Access Compliance Report Public Rights-of-Way (Curb Ramps)

Main Street: BALIZA_RD		Cross Street: ANDAZA_ST		Location:	SW
ADA ID: RPRK211129135614	Ramp Type: Type 4 - Parallel	Initial Pass/Fail: Fail	Overall Compliance: No	Severity Score:	32

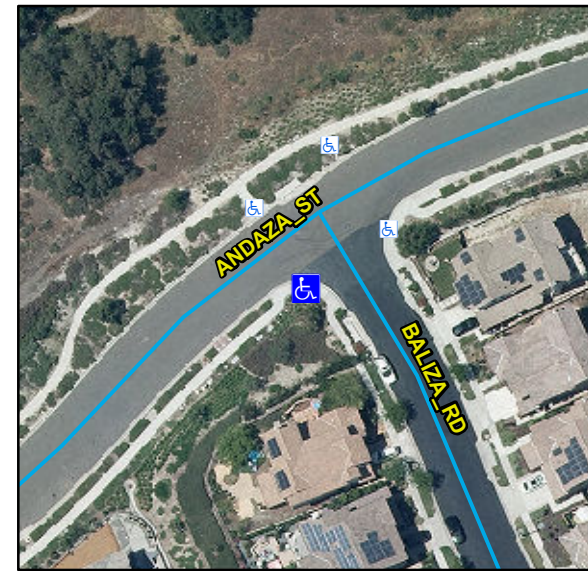
Codes/Mitigation Info/Possible Solution		Field Measurements/Component Compliance	
---	--	---	--

Compliance	Description	Data	Compliance	Description	Data
N/A	Ramp Length LT (in)	113	N/A	Ramp Length RT (in)	103
Yes	Ramp Width LT (in)	54	Yes	Ramp Width RT (in)	54
No	Ramp Run Slope LT (%)	15.8	No	Ramp Run Slope RT (%)	8.5
Yes	Ramp Cross Slope LT (%)	2	Yes	Ramp Cross Slope RT (%)	0.1
N/A	Landing Present	N/A	N/A	DWS Provided	N/A
N/A	Landing Length (in)	N/A	N/A	DWS Contrast	N/A
N/A	Landing Width (in)	N/A	N/A	DWS Length (in)	N/A
N/A	Landing Run Slope (%)	N/A	N/A	DWS Full Width	N/A
N/A	Landing Cross Slope (%)	N/A		DWS Offset Type	N/A
N/A	Landing Movement Obstructed?	N/A	N/A	DWS Offset Left (in)	N/A
	Landing Movement Type	N/A	N/A	DWS Offset Right (in)	N/A
N/A	Landing Shared	N/A			
N/A	Clear Space	Yes			
N/A	Clear Space To Crosswalk (in)	N/A			
N/A	Marked Crosswalk 1	No	N/A	Marked Crosswalk 2	No
	Crossing 1 Direction	E		Crossing 2 Direction	N
	Marked Crosswalk 1 Width (in)	N/A		Marked Crosswalk 2 Width (in)	N/A

Remove & Replace Curb Ramp With Two New Directional Ramps or Equivalent.
